**Proposed Residential Development with Minor Relaxation of Plot Ratio, Building Height and Site Coverage Restrictions  
at 44 Stanley Village Road in Stanley**

**- S16 Planning Application (TPB Ref.: A/H19/87) –  
Further Information No. 3**

**RESPONSE-TO-COMMENT TABLE**

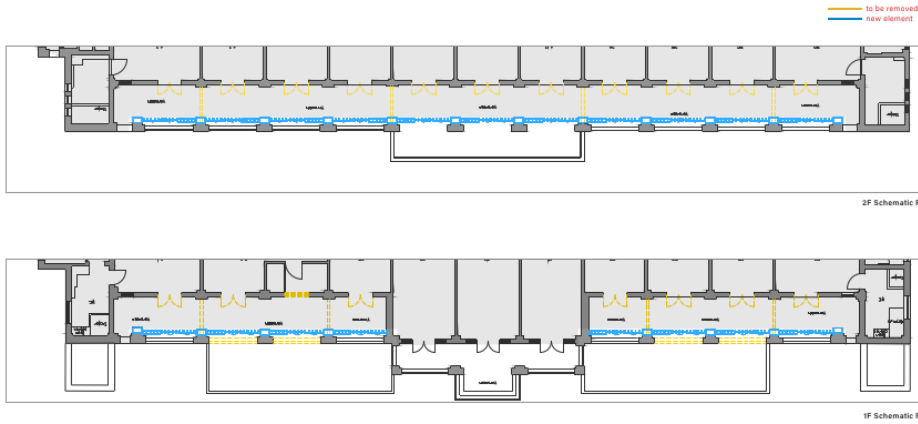
<p><b><u>Comments from Antiquities and Monuments Office:</u></b> <b>(Contact Person: Ms Carmen WONG, Tel: 2655 0828)</b></p>	
<p><b>I. Supporting Planning Statement</b></p>	
<p>1. <u>Modifications to the South Elevation</u> According to Section 5.4.4 of the Supporting Planning Statement (page 27) and the plans for the South Elevation in Appendix E - Design Proposals of the Conservation Management Plan (pages 146 to 148), to suit the proposed use of Maryknoll House (the "Graded Building"), some of the existing wooden doors/windows (except those of the central protrusion bay on 1/F) on 1/F and 2/F of the South elevation are proposed to be removed and replaced by the proposed glazing system to create habitable space at a desirable temperature to meet the modern living standard. Although that the proposed glazing system would be set back from the existing parapets and demolition is not required, please confirm that the proposed installation is reversible in nature and</p>	<p>We confirm that the installation of the proposed glazing system is reversible in nature, i.e. the necessary fixings to the existing building can be made good if the glazing system is removed. We confirm the Applicant would minimise any irreversible damage to the façade and parapets.</p> <p>The mitigation measures in the CMP relative to timber windows/doors is also updated to acknowledge that existing timber windows/doors where being removed, will be salvaged and reused for restoration/replacement on windows/doors in other locations.</p> <p>We would like to clarify that there will be some demolition of the existing parapets, with the extent identical to the south elevation in the</p>

<p>that the Applicant would minimise any irreversible damage to the facade and parapets. Besides, the Applicant should conduct a condition survey for the concerned wooden doors/windows. Efforts should be made to salvage them for the restoration/replacement of other windows and doors of other elevations wherever possible. Corresponding drawing(s) in the CMP should be updated accordingly.</p>	<p>approved CMP in January 2024. Some inner parapets within the verandah which are not seen from the exterior are clarified to removed, and the CMP is updated accordingly.</p> <p>At the point of publishing a CMP it would not be normal practice to have a fully resolved technical design. That aside, the principle of the glazing system has been established and mitigation measures have been updated to include the below points to guide the further design development and fixing arrangements:</p> <ul style="list-style-type: none"><li>- The design of the new glazing system to be compatible with but distinguishable to the existing.</li><li>- New additions should align with the language of other new external interventions across the main building.</li><li>- No new glazed enclosure to the central protrusion bay on 1/F. Following the general principle to replace timber doors/windows, new metal doors/windows of sympathetic design to the exterior facade, will also reference the design and characteristics of existing original windows.</li><li>- The fixing folding/sliding glazed enclosure shall be designed for reversibility, i.e. the necessary fixings to the existing building can be made good if the glazed enclosure is removed, with minimised irreversible damage to the façade and parapets.</li><li>- As a principle, fixing to the floor slab and underside ceiling soffit is preferred rather than to the facing brickwork piers. The setting out of shall not disturb the existing cornice feature. The glazed enclosure to be set back from the existing parapet so that a separation of 100mm min. is maintained. Division of the panels to be sympathetic with the glazed block distribution.</li><li>- A condition survey for the affected timber doors and windows on the South Elevation should be conducted. The concerned doors and windows should be salvaged for the restoration /</li></ul>
